Re: Re: Planning & Development Act 2000 and the Statutory Regulations made thereunder (as amended). Third party appeal by Robert McKenna, Saval, Saval Park Road, Dalkey, Co. Dublin, A96 PV27 and Shane Kirwan & Dr. Susan Murphy, Corcumrua, 2 Saval Park Road, Dalkey, Co. Dublin, A96 DR97; against the decision of Dun Laoghaire-Rathdown County Council to grant permission for development consisting of the demolition of the existing dwellinghouse and all associated structures on the site to allow the construction of four new residential dwellinghouses, consisting of a new part-one/part-two-storey 2-bed semi-detached unit & a new 3-storey 3-bed semi-detached unit both addressing Saval Park Road, and two new two-storey semi-detached 3-bed dwelling-houses to the rear of the site; all accessed via a widened pedestrian and vehicular entrance on Saval Park Road in the location of the existing vehicular entrance, private garden spaces to each unit, 4 no. off-street parking spaces and all associated site & drainage works at Lillegard, 1 Saval Park Road, Dalkey, Dublin, A96EC56.

Dun Laoghaire Rathdown County Council Planning Ref. D26A/0149/WEB

We, Marston Planning Consultancy, 23 Grange Park, F

Elevation of house no. 2 towards the rear of the site

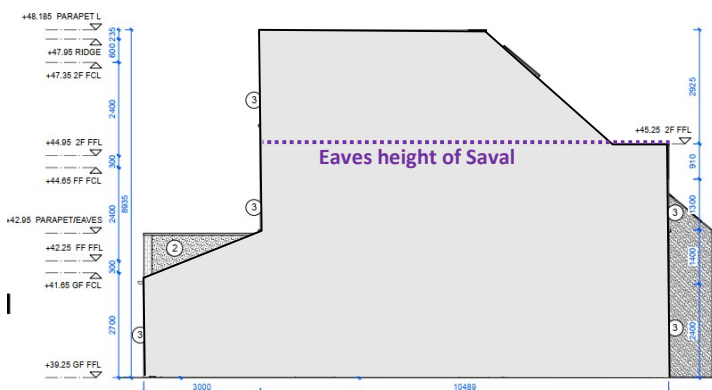
The front two houses have an incongruous design with house no. 1 indicated as being a two bedroom dwelling (84.85sqm) that extends beyond the front building line with the bedroom space within the roof that has a window within the gable elevation facing into the site. The front elevation reads as single storey with a large roof slope above. House 2 is presented as a three bedroom dwelling over three floors. It presents as being two storey, albeit with a protruding flat roof element, with a complex mono pitch roof above as it presents to Saval Park Road. It presents as a three storey flat roof block as it faces internally within the site (see below).

Notably, no side elevation of this block as it faces Saval is provided in any of the architectural packages submitted with the application, nor was it requested by the Council. House no. 2 is indicated as being located on and immediately adjacent to the shared boundary with Saval, and therefore only 0.9m from Saval's

northern side elevation where there are two glazed windows serving habitable spaces that will be materially and negatively impacted. For the clarity of the Commission, the height of the eaves of Saval is indicated by way of the broken purple line.

The three storey element forms a tower as it presents to the west, that is 8.935m in height, and will create an austere feature when viewed from both of our clients homes and gardens.

Side elevation of house 2, facing Saval

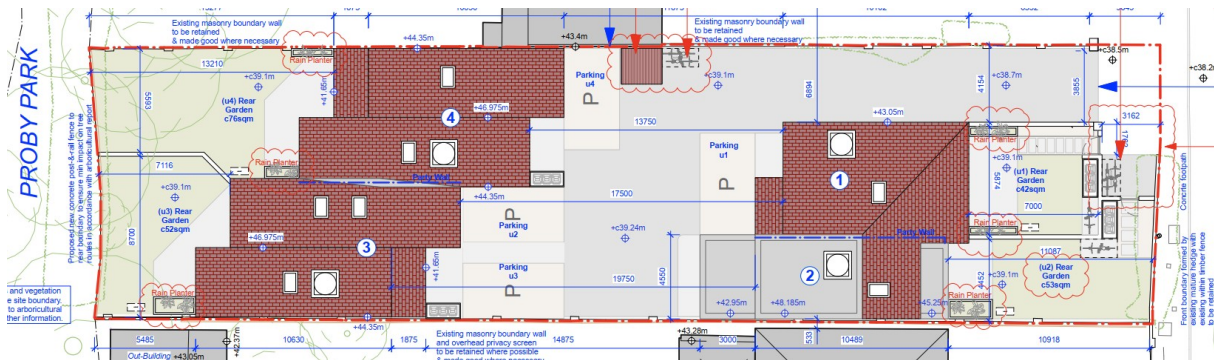
As part of the application it was proposed to amend the entrance and part of the front boundary facing Saval Park Road to provide a 3.855m wide vehicular entrance, and create pedestrian entrances into the rear gardens of house nos. 1 and 2 of the proposed development adjacent to Saval Park Road. Each dwelling was to be served by one car parking space.

The ill-considered nature of the proposed development is reflective in house no. 2 being below the minimum 102sqm required under Table 5.1 of the Quality Housing for Sustainable Communities Guidelines. This unit also fails to incorporate a master bedroom of 13sqm, as is required under the Guidelines. It is totally inappropriate to include a landing and bathroom within the calculation of the bedroom area, as is suggested by the applicant, and this is not supported by any Guidelines, and is grounds for refusal.

Approximate sightlines under FI site plan

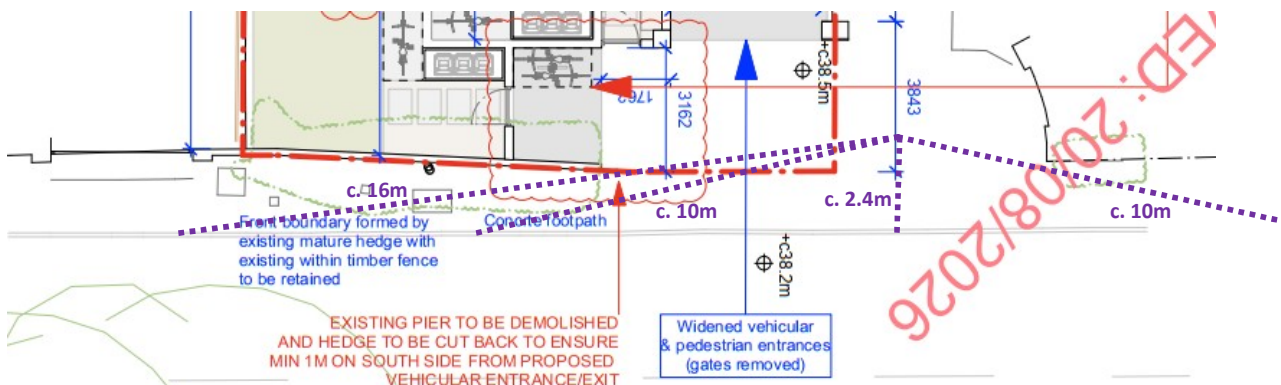
We have already, as did the Transportation Division of the Council, recognise visibility concerns at the access and recommended that the access sight lines should be checked carefully and the boundary walls adjusted as required with a view to optimizing visibility for drivers exiting the access (particularly to the south). DMURS-compliant sightlines have not been delivered.

The sightline to the right is below the requirement for even a 20km/h design speed. Even with a 2m setback, the sightlines are not provided to the left & right. This is compounded by the height of the front boundary wall – c. 1.8m, which is sought to try to achieve privacy to the front facing rear gardens. Once more reflective of the overdevelopment of the site

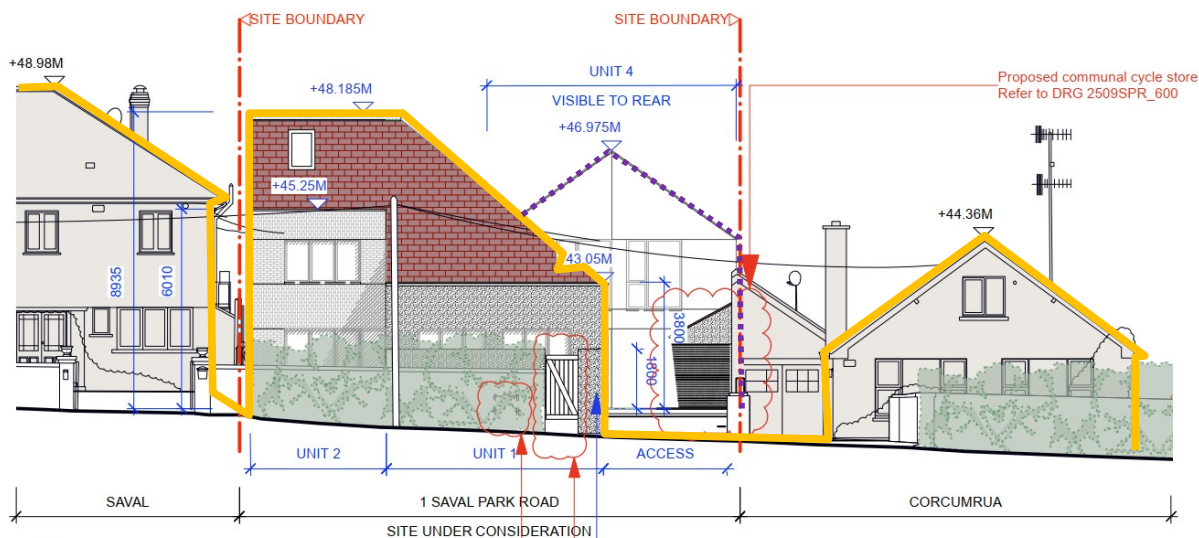
We also note that the autotrack / swept path analysis has been undertaken solely on a car size that has been not defined in the autotrack simulation submitted. The four car parking spaces are also not defined in terms of size and dimensions also. The autotrack also indicates the closeness of some of the turning movements to other spaces reflective of the overdevelopment being proposed.
